ECR/Documents for Information and Approval

Giulia Romagnoli and Natalya Kahn for BE-EA, 2024-09-03

LIST OF DOCs for APPROVAL

Figure 1: Installation locations.

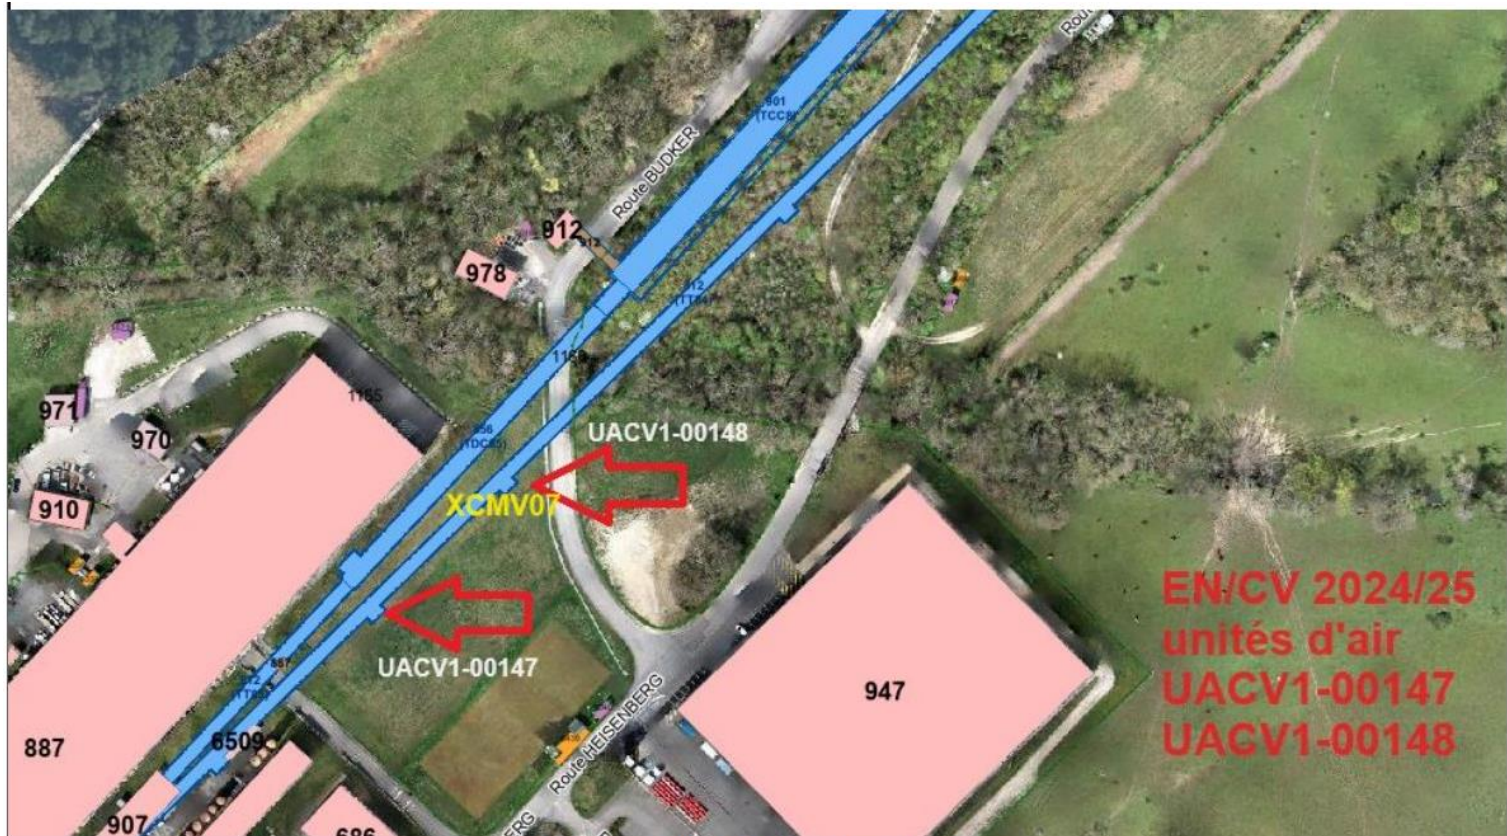
| Accepted with Warning by KADI Yacine (BE-EA) Could you please specify what are the RP concerns, if any, wrt the displacement and temporary storage of the magnetic collimator. | Created on 2024-08-05, 13:34 |
| Seen by BERTONE Caterina (EN-HE) We really need to know how these cubicles look like (size, dimensions, center of gravity) and to check if the new are different from the old ones. Just to check if we have everything that is necessary for handling or we need something else. As usual, we ask that construction drawings are sent to HE before drawing acceptance to the supplier to ensure installability. | Created on 2024-08-07, 16:49 |

| Accepted with Warning by LAZZARONI Michael (BE-EA) Thanks for the document. Do you have a 3D model (simplified) of it? I guess that you stay in the same volume that the present installation? if not we have to analyse it in ICEA meeting. thanks. | Created on 2024-08-09, 10:52 |
| Seen by RIOS RUBIRAS Oriol (HSE-OHS) would new units allow for interlock with Fire Detection? | Created on 2024-08-30, 09:08 |

| Accepted by ABERLE Frederic Lionel (HSE-RP) OK for RP. To answer Yacine's comment: the collimator will probably be slightly radioactive (I expect it to be in the order of a few uSv/h approximately). In my opinion, storage can be done in one of the radioactive storages at Preveessin, or temporarily in EHN2, or EHN1, or in the tunnel. | Created on 2024-08-13, 17:08 |
| Accepted by JENA Helmut (EN-CV) Reply concerning your comments (thanks to you all for collaboration): - Transport and handling of the racks done by Cern transport only (not done by contractor). - RP gives green light. Slight radiation only, no need even for protection drape. - Obsolete racks will be measured and temporarily stocked and disassembled in TDC85 (as the last years). - The new power racks have the same size as the old ones (no dedicated 3D model available) Thank you!! | Created on 2024-08-14, 11:25 |

Figure 4 – 3D scan and study for prototyping of QNL magnets.

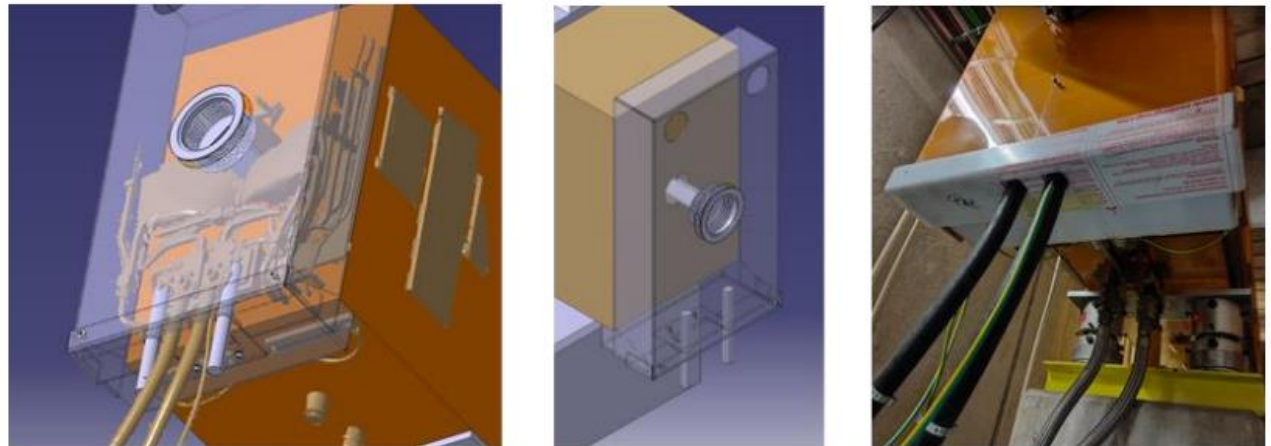
| ⚠ Accepted with Warning by VENDEUVRE Camille (BE-GM) Covers should not interfere with alignment system or survey reference points. The survey GIMSA are not visible on the drawings of QNL and QWL covers so it is difficult to estimate if there is interferences. The covers should be installed as low as possible in term of height so that the visibility of the sockets above the magnets is not affected. | Created on 2024-08-26, 09:17 |
